UNITED STATES PATENT AND TRADEMARK OFFICE

10/509,434

Office Action Summary

DETAILED ACTION

7. Claims 76-78 are rejected under 35 U.S.C. 103(a) as being unpatentable over Ledbetter 5,826,432 in view of Fujimoto 5,952,842 and further in view Applicant's admitted Prior art figure 1.

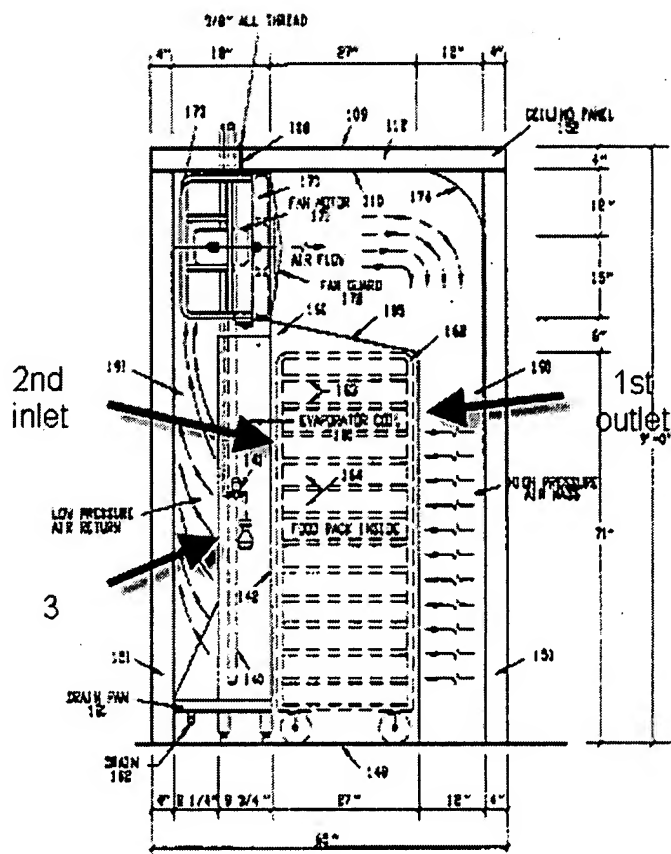
Ledbetter in view of Fujimoto teaches an invention as discussed above but is silent about an outer enclosure with external panels around the cabinet, an air conditioner between the cabinet and outer enclosure.

Applicant's admitted prior art (fig. 1) teaches the outer enclosure 4, 3, 5 with external panel 7 and 2, and air conditioner 16 between outer enclosure and the cabinet.

It would have been obvious to one of ordinary skill in the art to have the Ledbetter in view of Fujimoto apparatus within Applicant's admitted prior art enclosure and air conditioner in order to provide ventilation of the equipment inside the cabinet (spec. page 6, ll. 13-34 through page 8, ll.1-27).

(fig. 4 of Ledbetter)

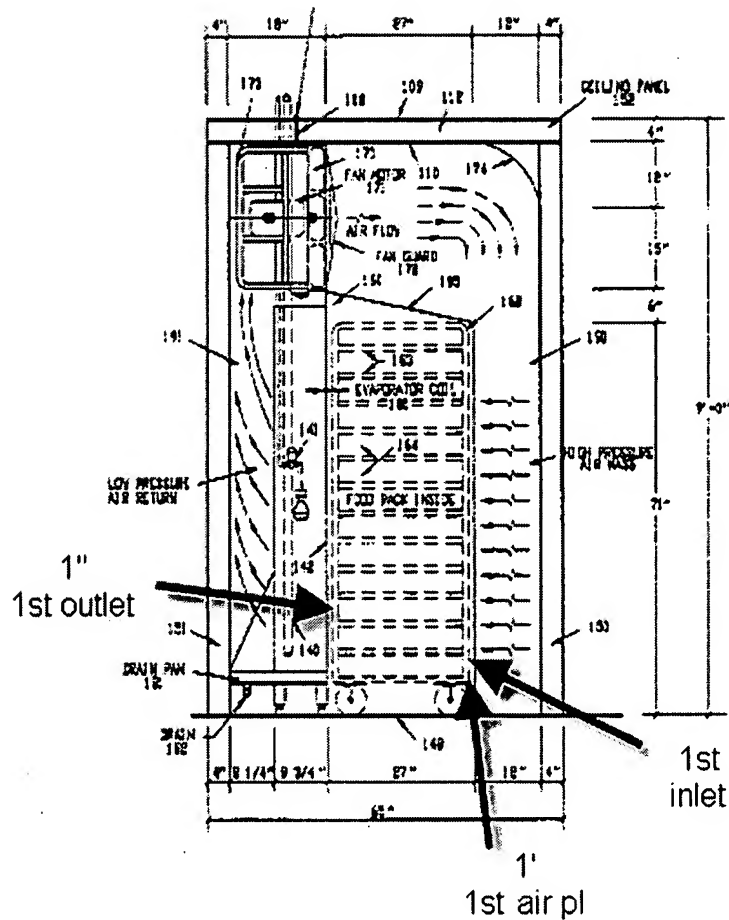
Ledbetter teaches an invention as claimed: a substantially sealed airtight cabinet (fig. 4) sized for housing vertical array of heat-producing units 162 having an exterior shell 109,190,151, an interior divider wall 160 disposed inside the cabinet wherein the shell and the divider wall provide an equipment chamber 164, 163, with a first plenum 190 and a first inlet 172 defined by the divider as an at least one substantially vertical slot, admitting the air uniformly over a substantial vertical length (fig. 4), **wherein the divider wall is configured such that the first inlet at least partially vertically overlaps with first plenum 190 (fig. 4) ; said shell and divider wall providing a heat exchanger chamber (on the right sight from divider wall 160) in which the heat exchanger 180 is disposed and an equipment chamber (on the left side from dividing wall 160) separate from the heat exchanger chamber (fig. 4);** a first outlet 1 (see paragraph 16 bellow of this Office Action, wherein examiner marked originally not marked first outlet 1 with darkened arrow for clarification) wherein the first plenum communicates with the openings for exhausting substantially all of the flow through the array in substantially horizontal direction (fig. 4); a second plenum 191 defined between the chamber shell and the array for receiving the air that has passed through the array having a second inlet 2 (see paragraph 16 bellow of this Office Action, wherein examiner marked originally not marked second inlet 2 with darkened arrow for clarification) and second outlet 3 (see paragraph 16 bellow of this Office Action wherein examiner marked originally not marked second outlet 3 with darkened arrow for clarification) defined by the divider wall such that the air is directed horizontally (fig. 4) from equipment chamber 164,163; **a heat transfer means 180 (col. 6, II. 21-25)**

disposed in the cabinet for carrying heat away from the cabinet; a door 210 (fig. 7) configured to provide selective access to the heat-producing units based on at least one of an environmental compatibility inside and outside the cabinet (fig. 11A), when the enclosure around the cabinet is closed (col. 9. ll. 47-63) wherein the doors have independent locks (fig. 11A).

Ledbetter teaches a cabinet as discussed above. However, regarding the limitation of the first plenum, inlet and outlet, Applicant's claims 52 and 56 are also rejected based on the consideration of the first inlet, first air plenum and first air outlet as shown in paragraph 16 of this Office Action. First inlet 1 described as first outlet in discussion above, with first air plenum 1' and first outlet 1" wherein the first inlet extends substantially a full vertical extent of at least one of the array and the first plenum.

Ledbetter teaches an invention as discussed above and further: a mechanism 173,180 for cooling and recirculation of the air between mechanism chamber 191 (fig. 4) and equipment chamber 163,164, wherein the shell and divider wall are configured to direct the air to the mechanism that may have at least one fan (fig. 16) positioned downstream from the fan wherein the flow of the air through equipment chamber 163,164 is substantially parallel to and opposed to the flow of the air through mechanism chamber 191 (fig. 4);

8. Examiner marked originally unmarked elements with darkened arrows for clarification.
